Mondol Intimates Limited New Building

Shirir chala, Bagar Bazar, Mohona Bhabanipur, Gazipur sadar, Gazipur, Bangladesh
(24.1651181 90.4287471)
10th February 2021

Observations

Over Head Water Tank Section

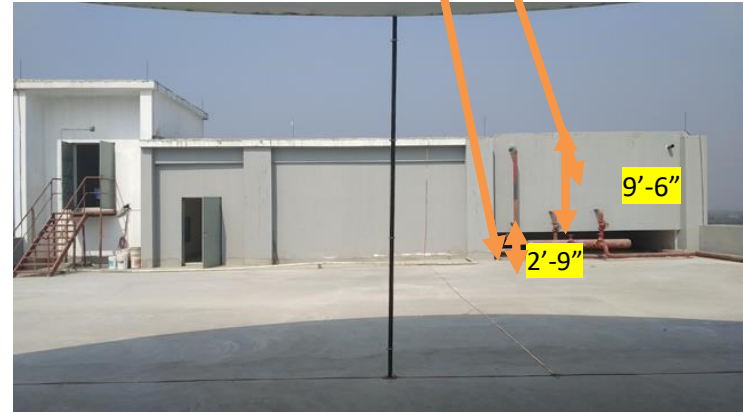
Discrepancies in as-built drawing

| Item No. | Observation | Recommended Action Plan | Recommended Timeline |
|----------|---|--|----------------------|
| 01 | Discrepancies in as-built drawing [Building 2]. | Factory Engineer to survey the structure and prepare accurate as-built (architectural and structural) drawings in compliance with section 1.9.1.2 as per BNBC. | 6-weeks |

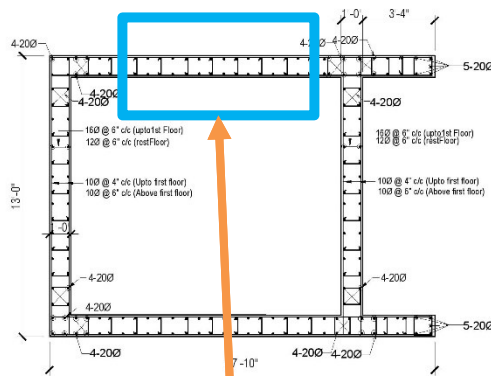
Gardening-Not shown in drawing

Stair (Roof to Helipad) supported by two brick wall, but one brick wall is shown in drawing

Lift Wall Reinforcement Detail (SW1)
Below EGL AND 1ST TO TOP FLOOR

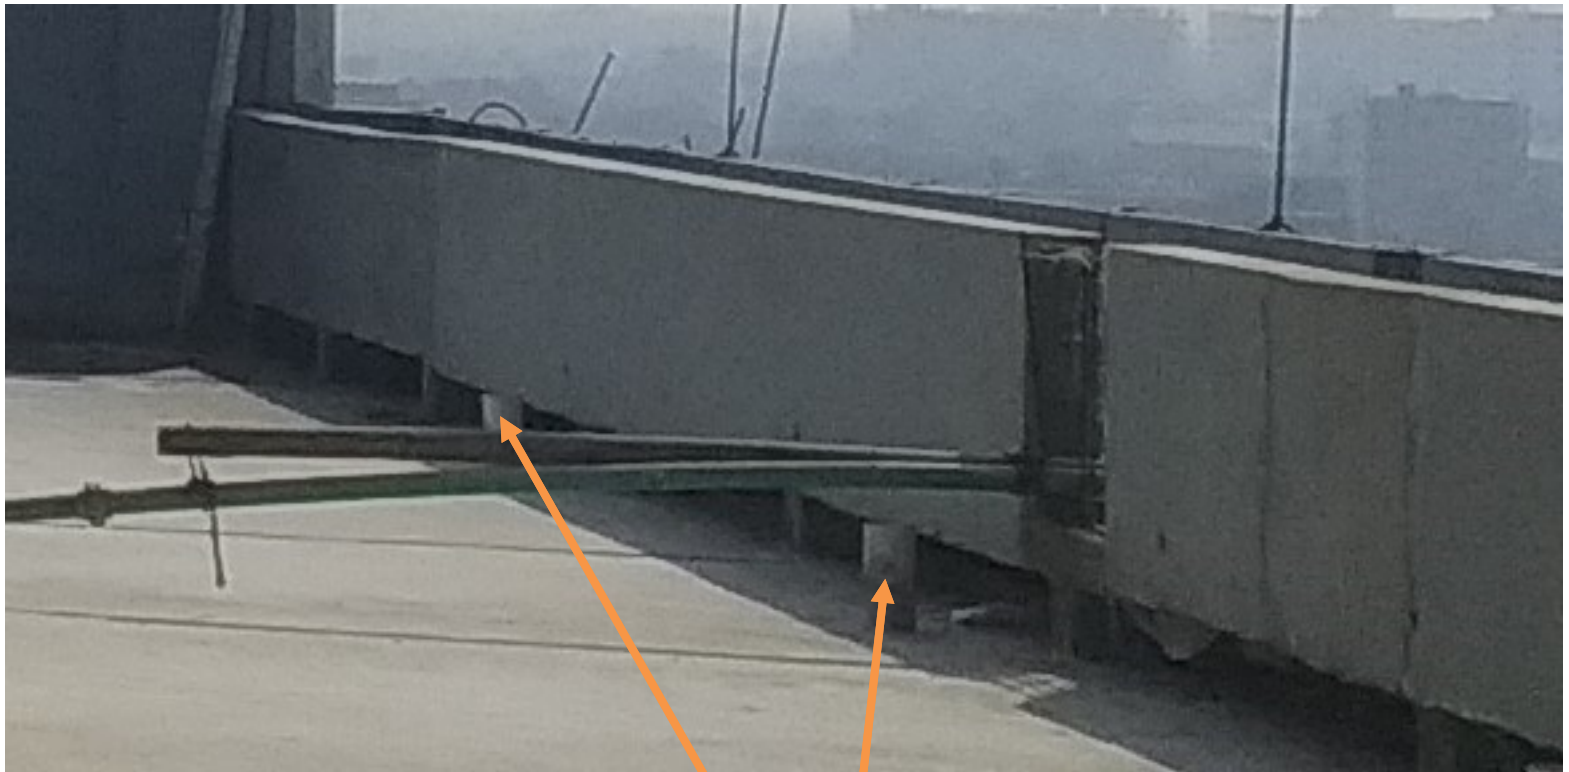
SW1: Door Opening-
Not Shown in Drawing

Canopy at North-West Corner-Not Shown in Drawing

Adequacy Check of Canopy.

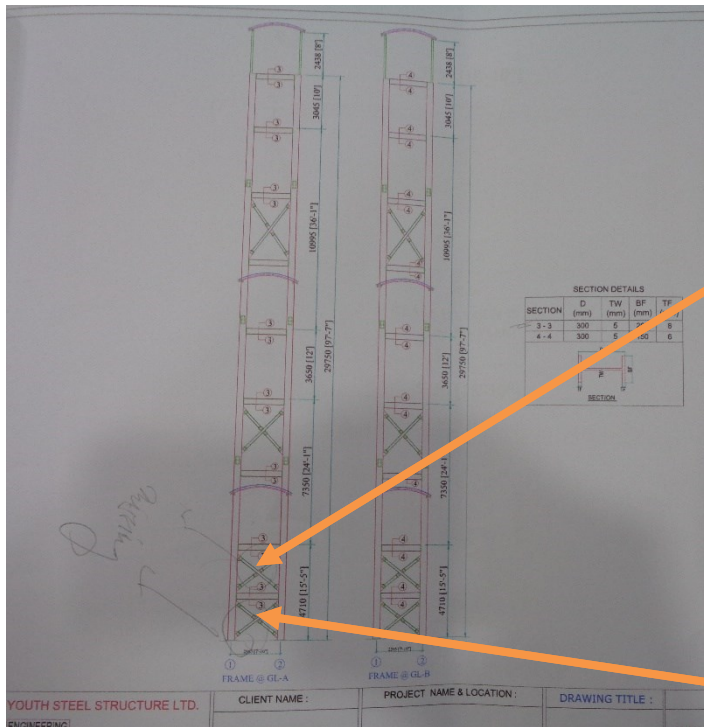
Crack in brick wall

Cracks was found in brick wall supporting stair (roof to helipad). Factory engineer is required to investigate the cause of crack and repair the crack as per recommendation from investigation report.

Inactive drainage pipe at roof

Drainage pipe is not active at roof.

No detailing of canopy. Factory is required to produce detailing and check adequacy of canopy.

| Item No. | Observation | Recommended Action Plan | Recommended Timeline |
|----------|---|--|----------------------|
| 02 | Crack in brick wall [Building 2]. | Factory engineer is required to investigate the cause of crack and repair the crack as per recommendation from investigation report. | 6-weeks |
| 03 | Inactive drainage pipe at roof [Building 2]. | Factory engineer is required to remove all obstacles from inlet of roof drainage pipe and improve roof drainage system. | 6-weeks |
| 04 | Adequacy Check of Canopy [Building 2]. | Factory engineer is required to produce as-built drawing in compliance with section 1.9.1.2 as per BNBC. | 6-weeks |
| 05 | Adequacy Check of Canopy [Building 2]. | Check adequacy of member size and connection of canopy. | 6-weeks |
